**TP199344 MODIFICATION KIT**  
**AND TP117176 FUSE**

*APPARATUS AFFECTED:* 35A and 35B Call Control Units.

*OBJECT:* To prevent grounding the transistor case, and to provide delayed-action-type fuses.

**SECTION 574-227-800.06**

Fig. 1

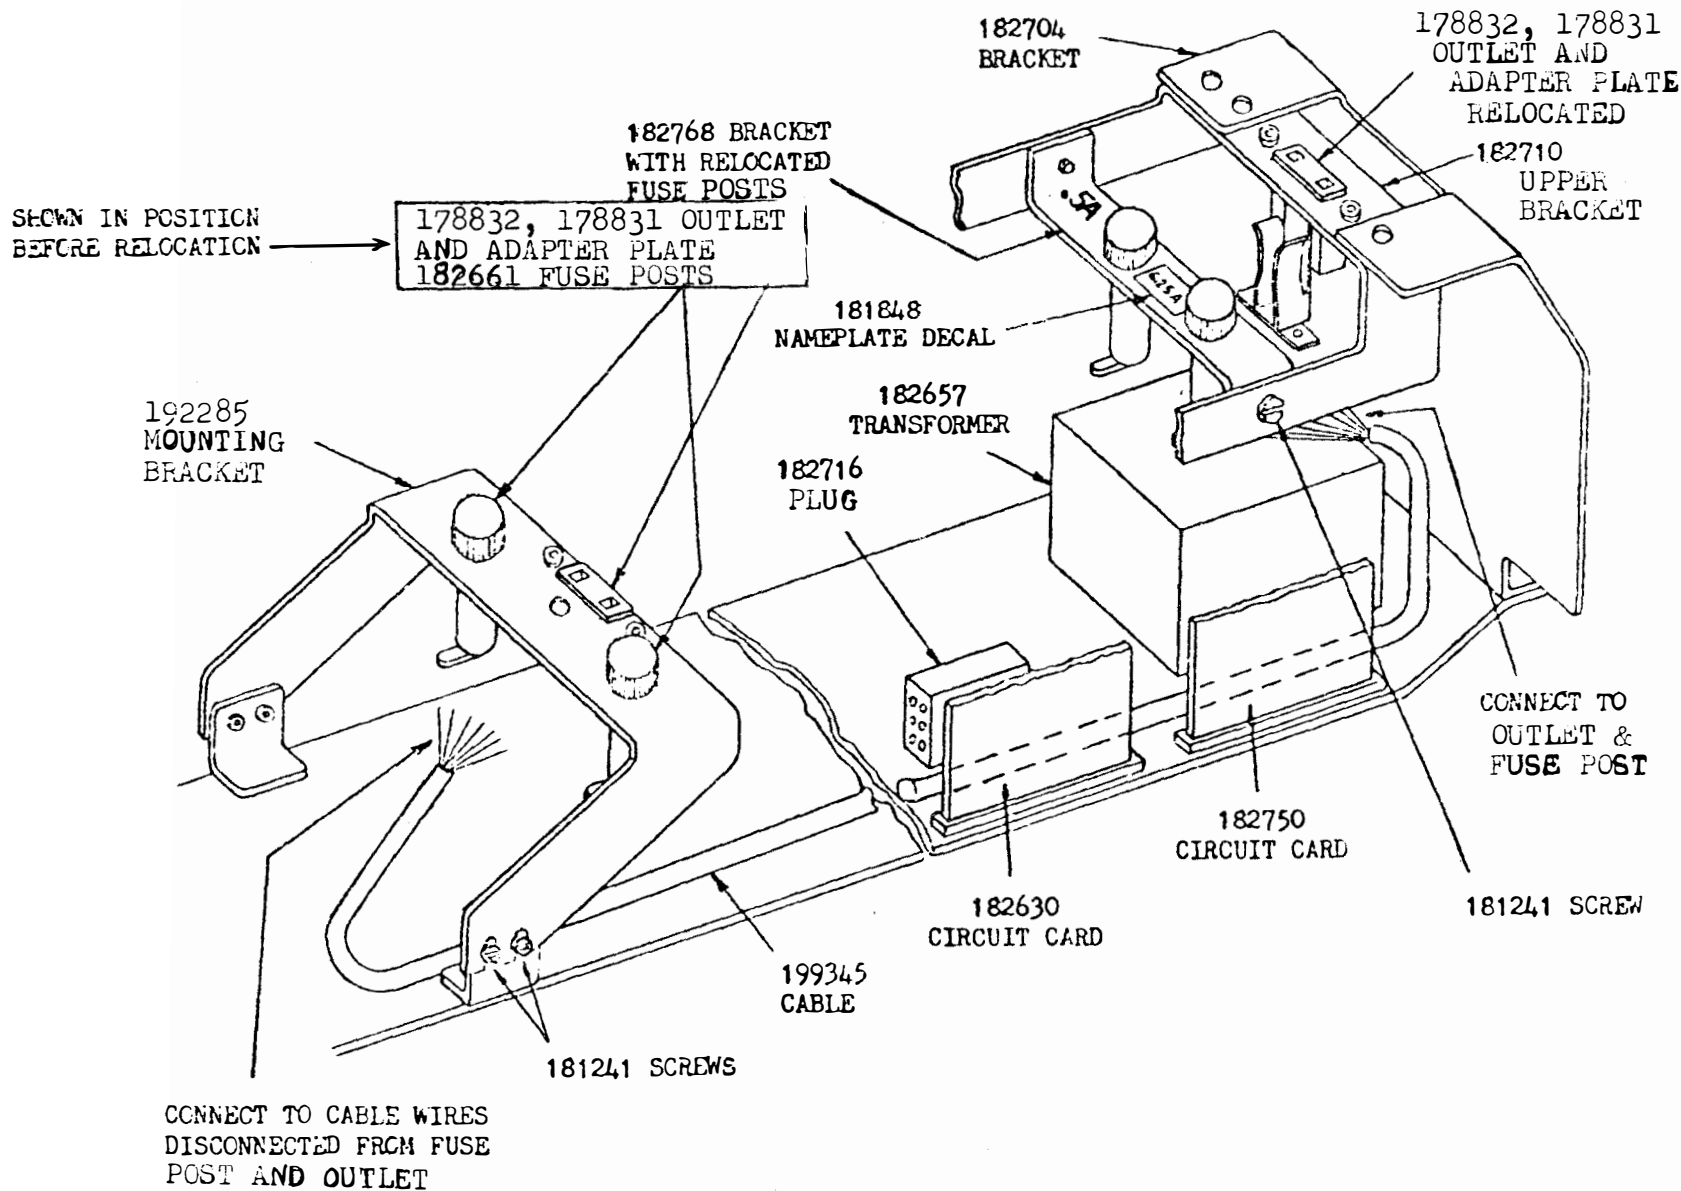
- (b) The TP178831 outlet and the TP178832 adapter plate are removed from the TP192285 mounting bracket and are now mounted on the TP182710 upper bracket. (See Fig. 1.)

- (c) A new TP182768 bracket is mounted between the sides of the TP182710 upper bracket. (See Fig. 1.)
- (d) The two TP182661 fuse posts are removed from the TP192285 mounting bracket and are now mounted on the TP182768 bracket. (See Fig. 1.)

- (e) The TP192285 mounting bracket is removed and discarded.
- (f) A TP181848 fuse-identification plate (6.25A) is added to the TP182768 bracket, between the two TP182661 fuse posts. (See Fig. 1.)

- (g) A fuse-rating designation (.5A) is stamped on the TP182768 bracket, adjacent to the TP117176 fuse. (See Fig. 1.)
- (h) A power-rating designation (100 WATTS MAX) is stamped on the TP182710 bracket, adjacent to the TP178831 outlet.
